Friday, 09/03/2007 2:26:24 PM Linda Lacelle **Process Sheet** : BRACKET **Drawing Name** : CU-DAR001 Dart Helicopters Services : 31156 : 10810 **Estimate Number** : D3177041 : NA Part Number S.O. No. : NA . D3177 REV B2 : 09/03/2007 **Drawing Number Project Number** : N/A : MACHINED PARTS : B2 **Drawing Revision** Type : NA : 24923 Material : 16/03/2007 Qty: 2 Um: Each **Due Date** Checked & Approved By : Est Rev:B 03.01.27 Added Step 12 KJ/RF **Additional Product** Description: **Machine Or Operation:** M6061T6B1000X12000 6061-T6 Bar 1.0" x 12.6 Comment: Qty.: 2.0747 f(s)/Unit Total: Material: 6061-T6 (QQ-A-200/8) or (QQ/A-250/11) 1.00" hick(Ms061T6B1.000x12.000 or M6061T6S1.000) Batch: <u>M9601</u> BAND SAW BAND SAW Comment: BAND SAW Cut blank: 47.40" x (12.000" +0.100/-0.000) HAAS CNC VERTICAL MACHINING #1 HAAS1 Comment: HAAS CNC VERTICAL MACHINING #1 1-Machine part as per Folio FA291 and Dwg D3177 2-Deburr INSPECT PARTS AS THEY COME OFF MACHINE 4.0 QC2 Comment: INSPECT PARTS AS THEY COME OFF MACHINE SECOND CHECK 5.0 QC8 Comment: SECOND CHECK

D3065-5DART AEROSPACE LTD	Work Order:	31150
Description: Bracket	Part Number:	D3177-1
Inspection Dwg: D3177 Rev: B2		Page 1 of 1

Subject

DESIGN (DRAWN BY	DART AEROSPA HAWKESBURY, ONTARIO,	
'	CHECKED	APPROVED A	DRAWING NO.	REV. B
	#	#	D3177	SHEET 3 OF 3
1	DATE		TITLE	SCALE
	03.01.07		BRACKET	1:1

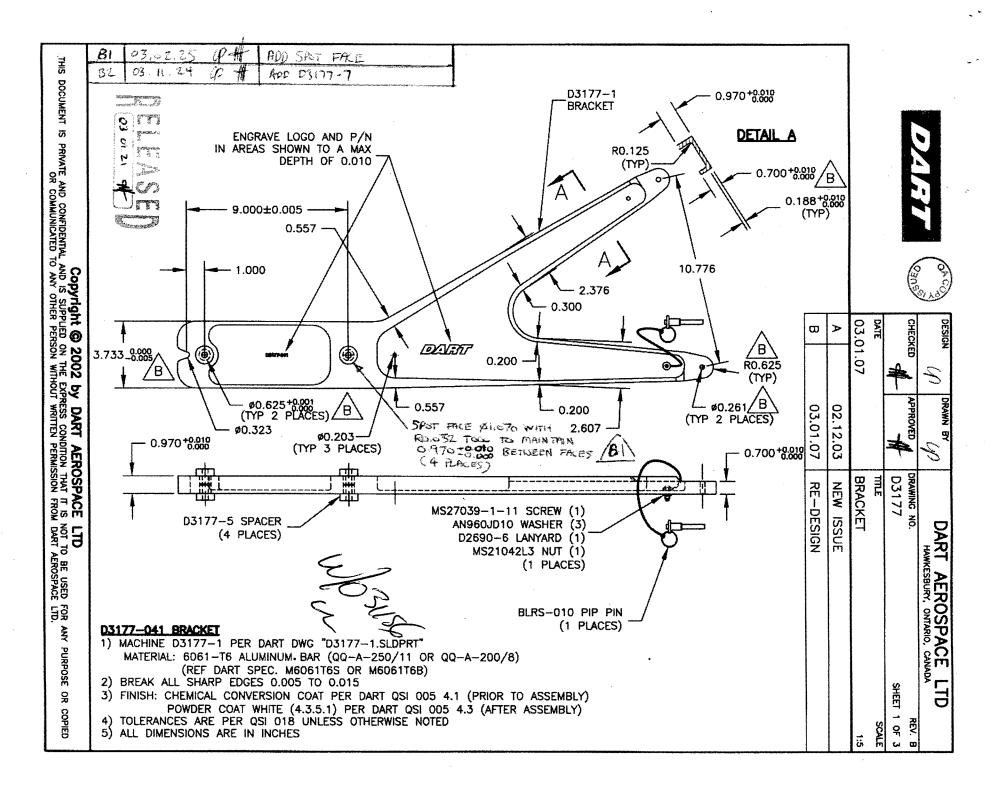
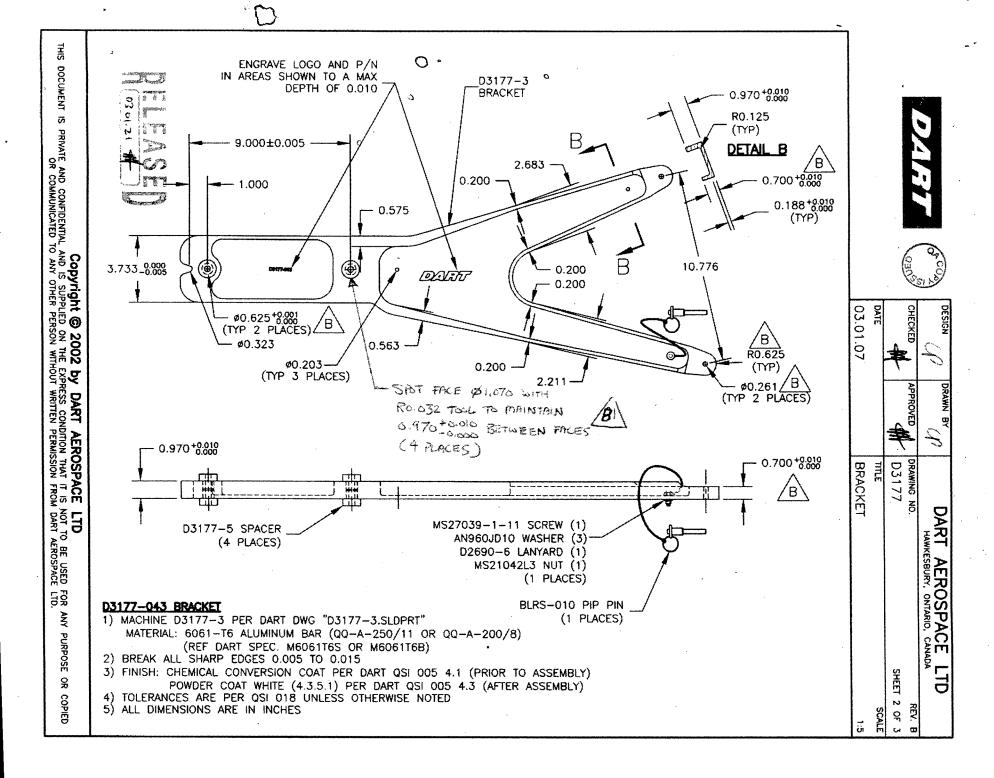
Apparently, production has made a couple D3177-041 and D3177-043 Brackets with incorrect dimensions. The 0.970" thickness dimension was cut too short, to approximately 0.945". I've been punching the new number into the SR-D130-701-1 stress report to see if the brackets can still support the loaded basket.

Section C-C is the critical section for both parts. Using 0.945", and the method shown in SR-D130-701-1, the parts will yield (see Stress Analysis.pdf), so it looks like they are unacceptable, but I think the analysis is a little too conservative.

If you look at the calculations in Section 6.0 of the stress report you can see that 30" was used as the moment arm for Section C-C (distance from the section to the centroid of the bracket plus basket area), while Section A-A and Section B-B both used different (smaller) moment arms (from the section to the mounting hole). If you calculate the stress at Section C-C using a similar moment arm as A-A and B-B (from the section to the mounting hole, see Stress Analysis.pdf) the margin of safety is positive and acceptable. I don't see why a moment arm of 30" was used for Section C-C (except for being extra conservative) since the basket is not bending and the load on the part is actually applied to the mounting holes.

Do you think this deviation is acceptable or should the parts be scrapped?

Please scrap all D3177 parts.

I'm not sure I agree with your assessment. Besides, I don't have the authority to change the analysis. Therefore, the D3177-041/-043 parts that were cut to 0.945" should be scrapped.
